**Terex Utilities****SAFETY NOTICE****SN719****DATE: 6/21/2023****REVISED:****TO: Owners, Users, Dealers, and Installers****MODELS AFFECTED: TL48****SUBJECT: Subframe Insert Welds****Issue:**

Figure 1. Area of subframe to inspect

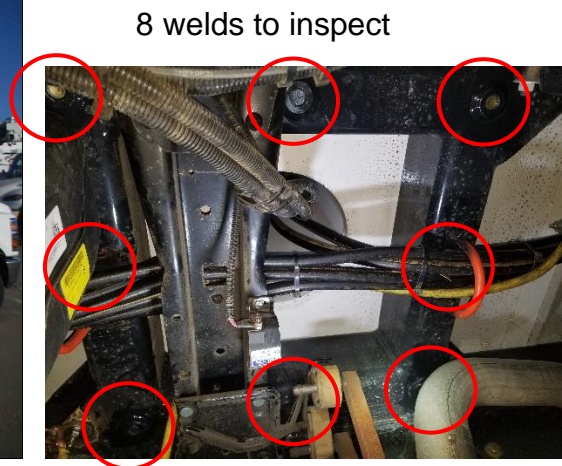
Terex TL48 model aerial devices, produced from February 2021 through September 2021, may have subframe weld issues. The welds for the threaded inserts that the aerial device mount to may crack loose from the surrounding subframe material. **Failure of the subframe welds could cause the boom to separate from the truck frame which could result in injury or death.**

1. Immediately inform all users, operators, and supervisors that the bottom side of the subframe where the aerial device mounts must be visually inspected before further use.
2. Inspect to determine if welds are cracked for the threaded inserts using the figures below as reference.

Inspect this weld  
for cracks

3. If no cracks are detected during the visual inspection the unit can be used following the instructions in the continued use section in this bulletin as well as all operator, maintenance, and inspection requirements as specified in the manuals.
4. If cracking is detected in the welds, do not use the machine and contact Terex Utilities Warranty Department using the contact information in this bulletin.

Terex will complete Field Service Kit Z1650 at no cost to the customer. The Field Service Kit Z1650 provides instructions for removing the welds for the threaded inserts at the top of the subframe and to reweld the top side of the inserts to the subframe tubes.
